ADDENDUM NO. 3
SEWER SYSTEM IMPROVEMENTS
CONTRACT 18-01
15 MG PRESTRESSED CONCRETE STORAGE TANK
PADUCAH MCCRACKEN JOINT SEWER AGENCY
PADUCAH, KENTUCKY
WAUFORD PROJECT NUMBER 2081
CLEAN WATER REVOLVING LOAN FUND #A12-08

Date of Addendum: Friday, June 15, 2018

△ SITE PRELOADING PLAN
SCALE: 1"=60'

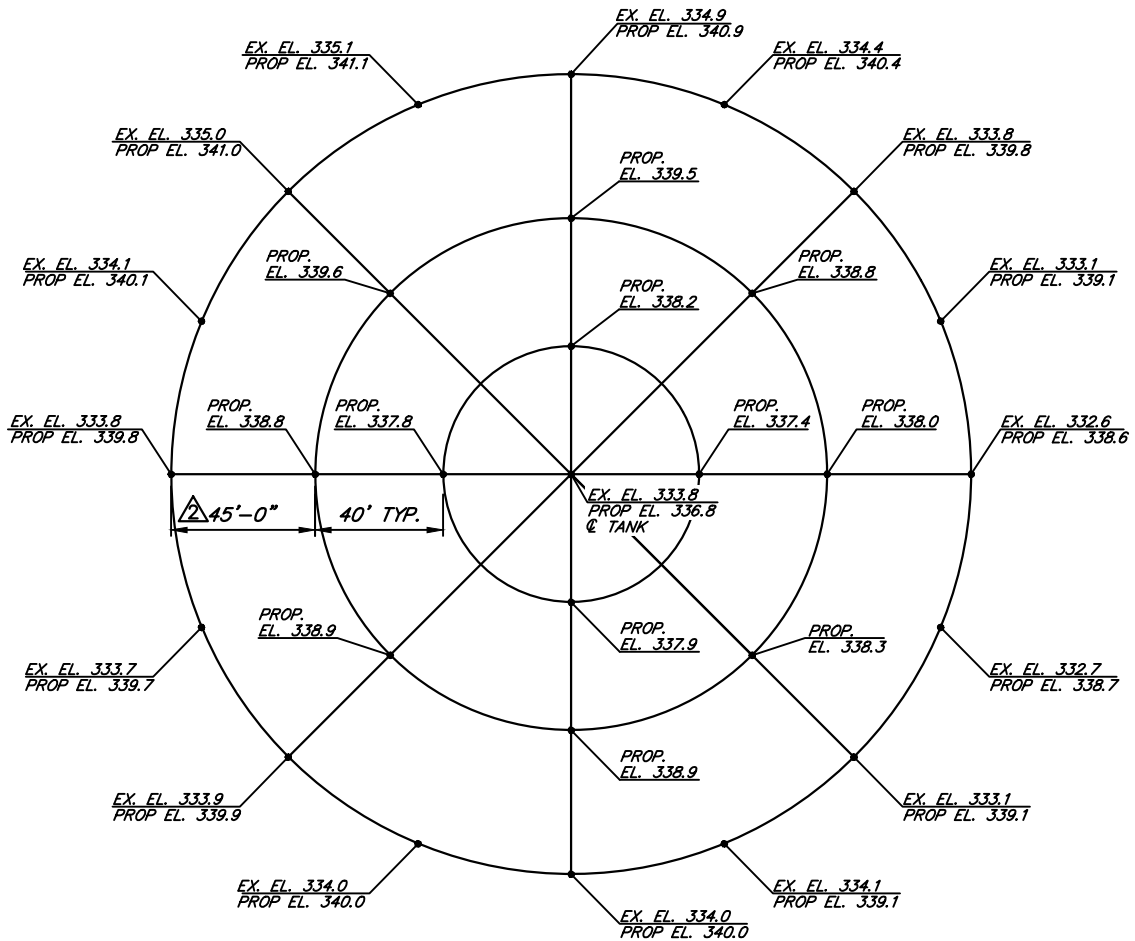
5. Plans, Sheet 2:

Revise as shown on the attached 8 ½ “ x 11” sheet.

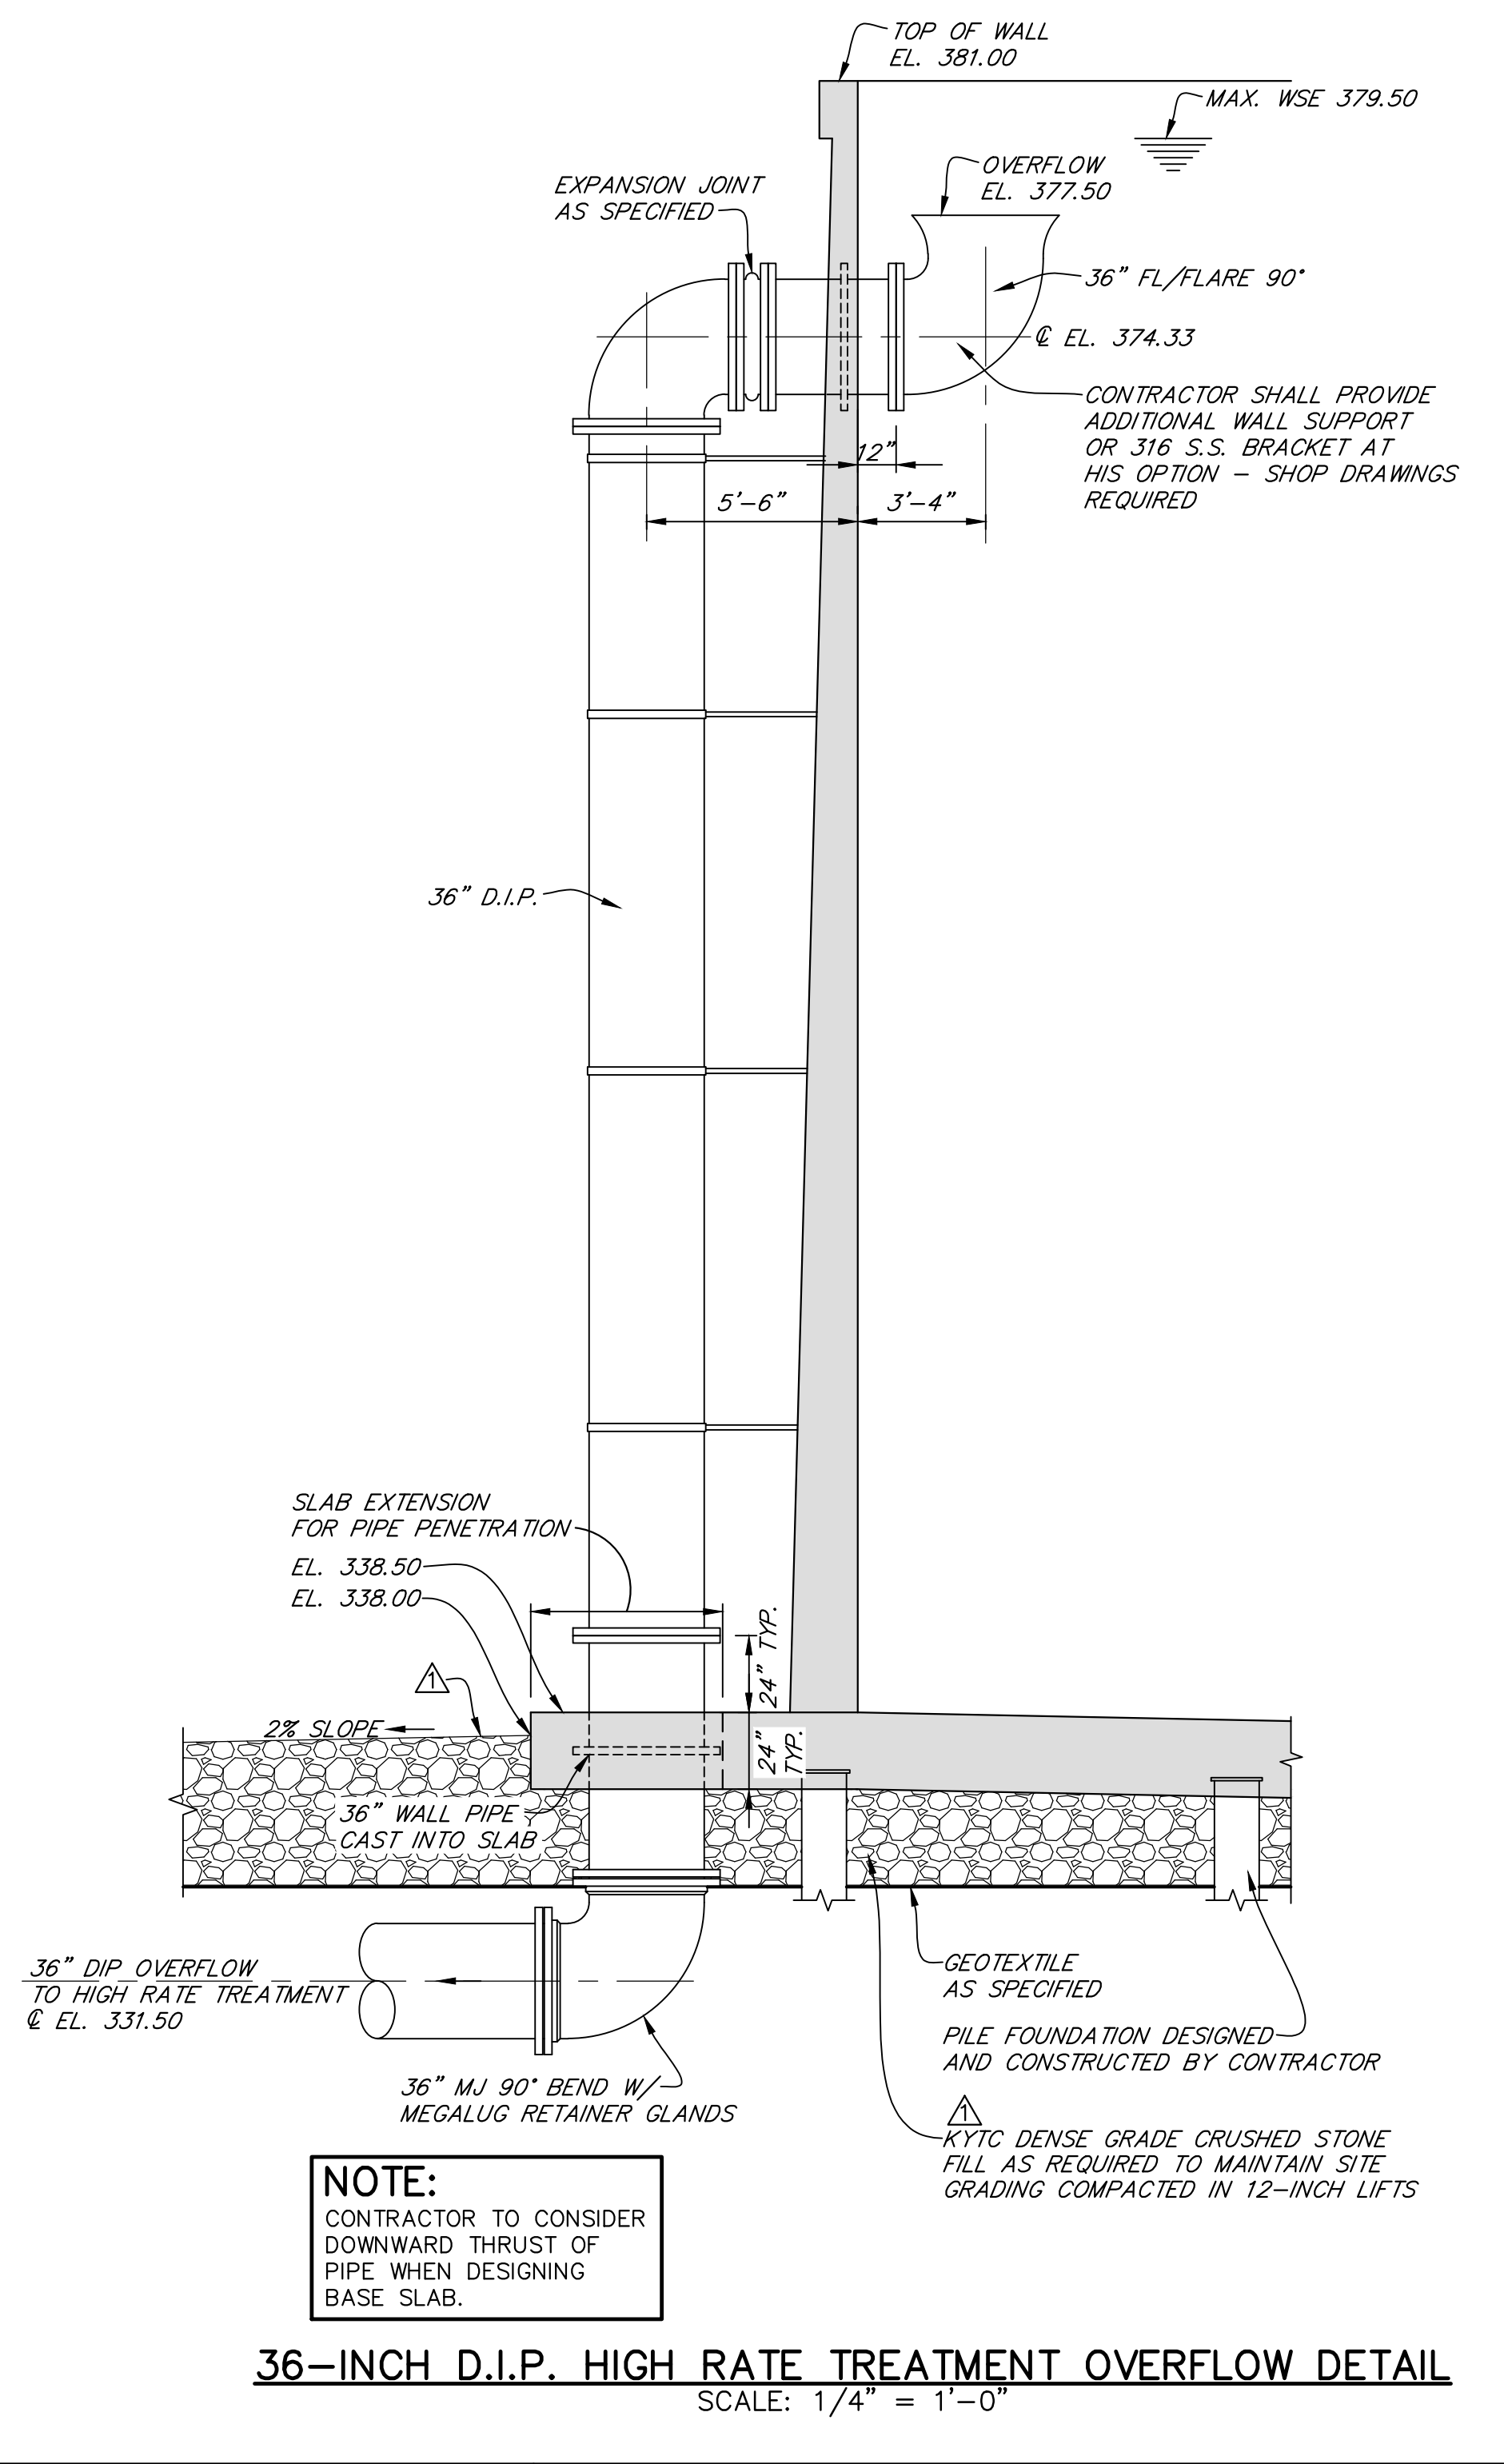
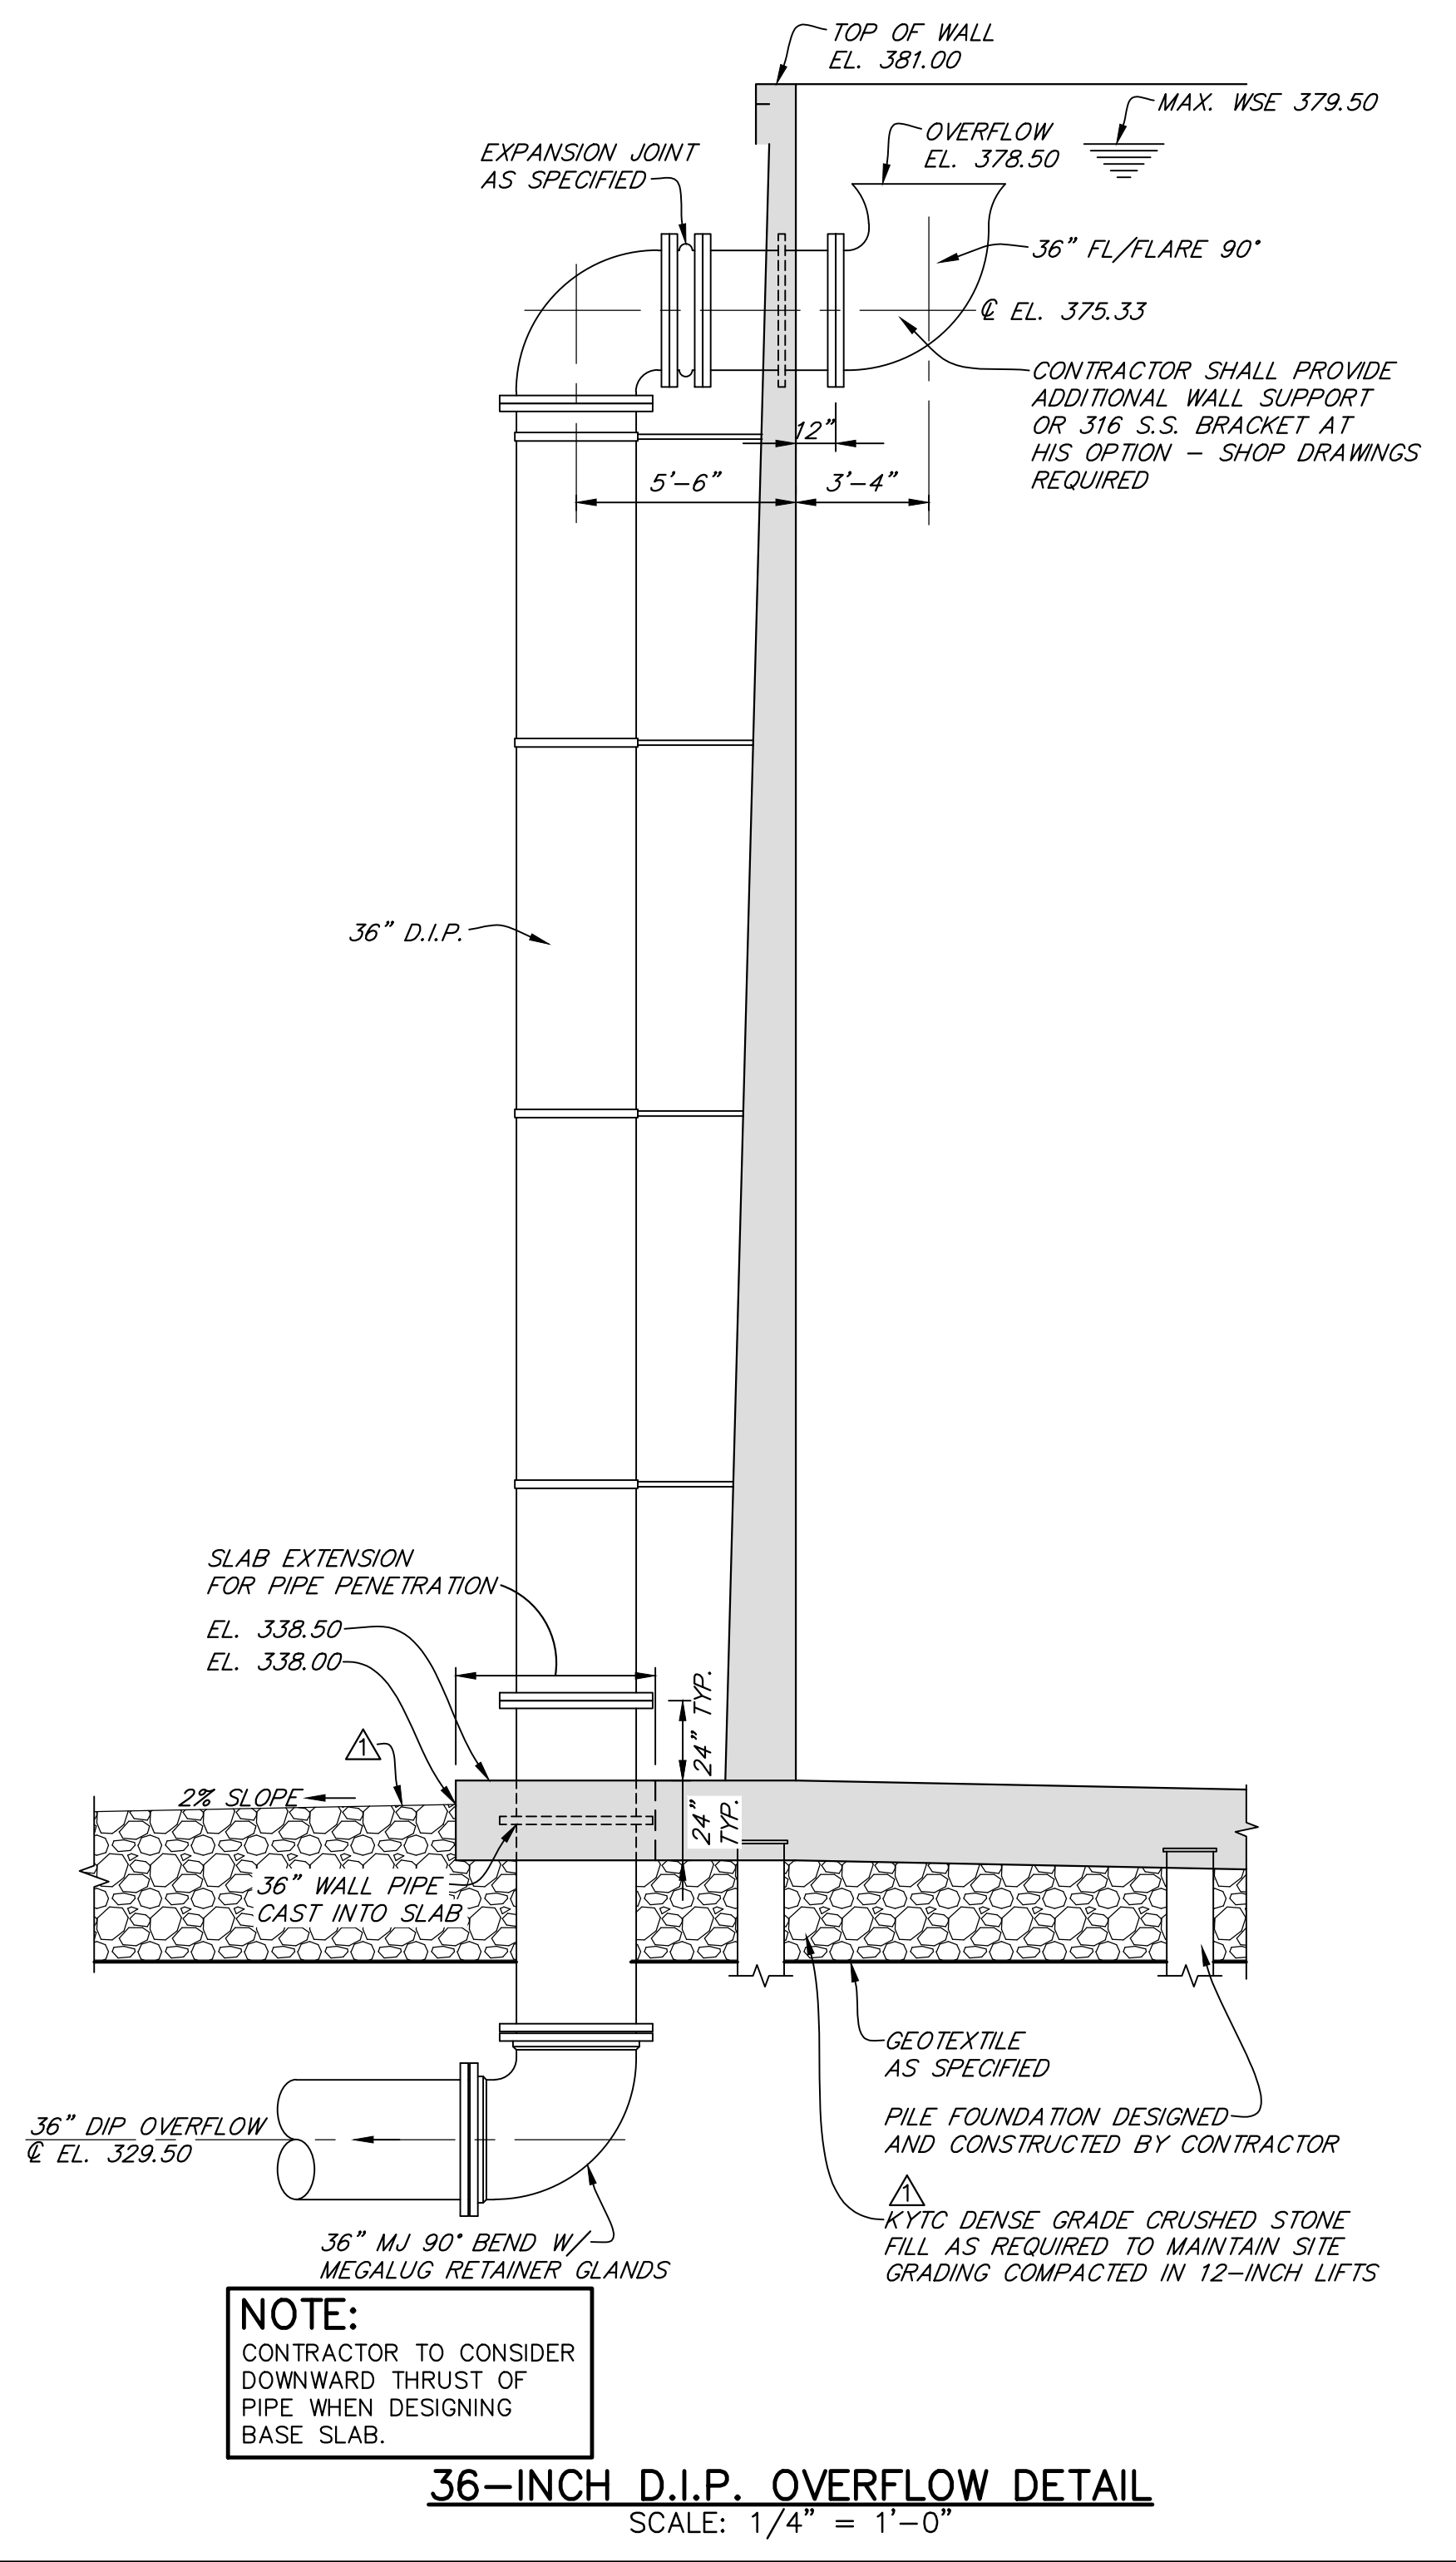
6. Plans, Sheet 4:

Revise as shown on the attached Plan sheet.
